APPLICATION NO.	FILING DATE	FIRST NAMED INVENTOR	ATTORNEY DOCKET NO.	CONFIRMATION NO.
10/673,680	09/26/2003	Robert L. Doubler	2131.023	2033

Office Action Summary	Application No. 10/673,680	Applicant(s) DOUBLER ET AL.	
	Examiner James L. Swiger	Art Unit 3733

DETAILED ACTION

FIG. 14

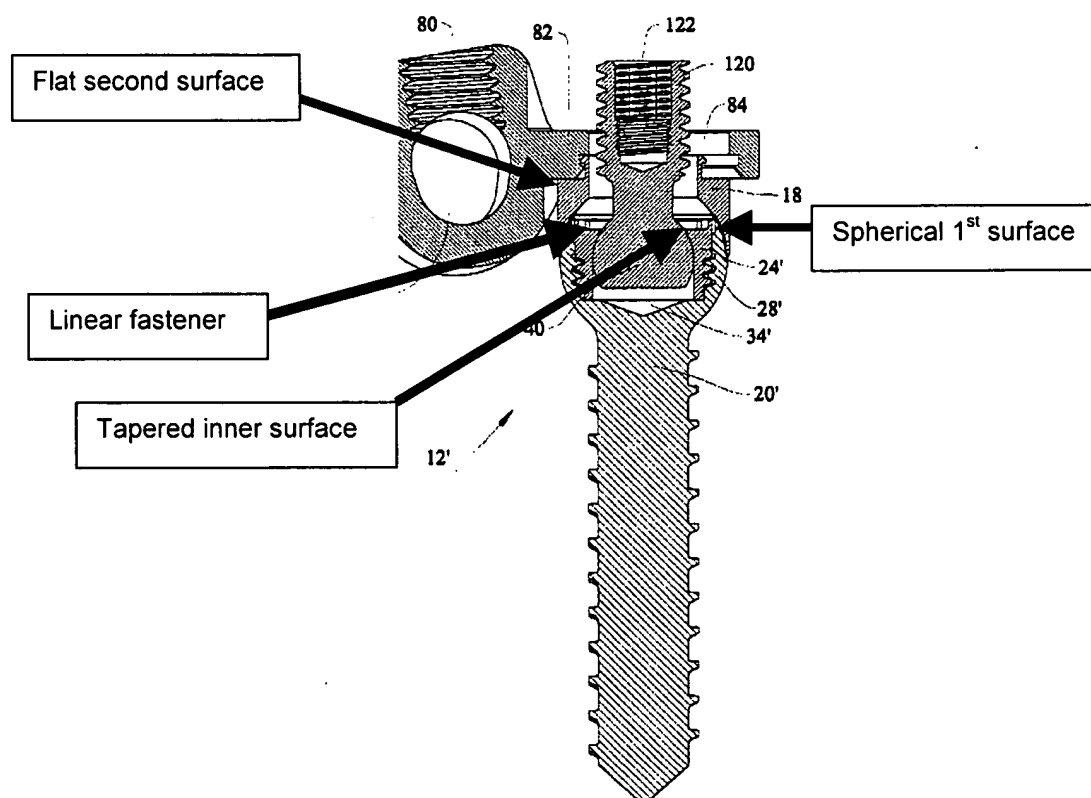
that is adapted for swivelable attachment to a linking member (Fig. 3, 32). Mullane further discloses a connecting member (82), and a portion that is capable of function as linear fastener. See Drawing of Fig. 14 below. The linear fastener also would fixedly engage about the linking member machined end to produce a clamping force.

In addition to the bone screw of Fig. 2 having a substantially spherical second end (opposite the threaded portion), Mullane also discloses a support collar (18), with a substantially spherical first surface and a generally flat second surface both of which aid in providing a clamping force for locking the linking element. See Fig. 14 above. Mullane further discloses a collet member (24') with a tapered inner

compression surface (see Fig. 14 above), and also a linking member tensioning means that has an internal bore with threads (122) that is capable being gripped by a threaded attachment to provide the necessary tensile force with respect to the collet.
